Access Compliance Report Public Rights-of-Way (Curb Ramps)

Main Street: GILBERT_ST		Cross Street: GUINIDA_LN		Location:	NW
ADA ID: RPRK210924122212	Ramp Type: Type 4 - Parallel	Initial Pass/Fail: Fail	Overall Compliance: No	Severity Score:	2
Codes/Mitigation Info/Possible Solution			Field Measurements/Component Compliance

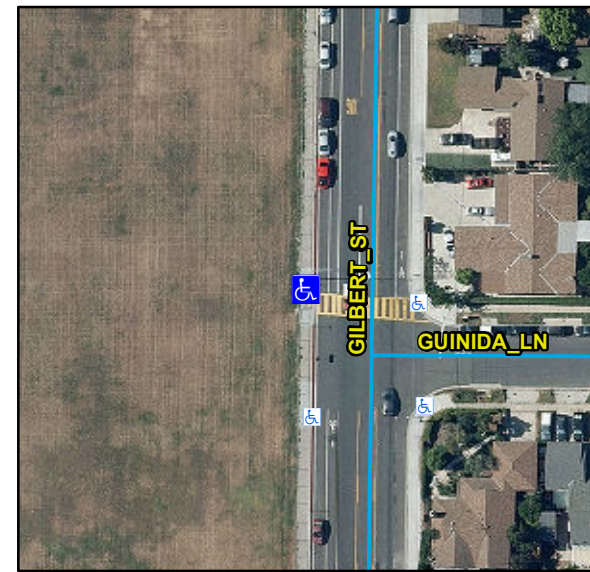
Compliance	Description	Data	Compliance	Description	Data
N/A	Ramp Length LT (in)	105	N/A	Ramp Length RT (in)	112
Yes	Ramp Width LT (in)	60	Yes	Ramp Width RT (in)	50
Yes	Ramp Run Slope LT (%)	1.6	Yes	Ramp Run Slope RT (%)	3.8
No	Ramp Cross Slope LT (%)	4.2	Yes	Ramp Cross Slope RT (%)	0.9
N/A	Landing Present	N/A	N/A	DWS Provided	N/A
N/A	Landing Length (in)	N/A	N/A	DWS Contrast	N/A
N/A	Landing Width (in)	N/A	N/A	DWS Length (in)	N/A
N/A	Landing Run Slope (%)	N/A	N/A	DWS Full Width	N/A
N/A	Landing Cross Slope (%)	N/A		DWS Offset Type	N/A
N/A	Landing Movement Obstructed?	N/A	N/A	DWS Offset Left (in)	N/A
	Landing Movement Type	N/A	N/A	DWS Offset Right (in)	N/A
N/A	Landing Shared	N/A			
N/A	Clear Space	N/A			
N/A	Clear Space To Crosswalk (in)	N/A			
N/A	Marked Crosswalk 1	Yes	N/A	Marked Crosswalk 2	N/A
	Crossing 1 Direction	E		Crossing 2 Direction	N/A
	Marked Crosswalk 1 Width (in)	150		Marked Crosswalk 2 Width (in)	N/A

Remove & Replace Entire Ramp.

R304.5.3, STD 1115
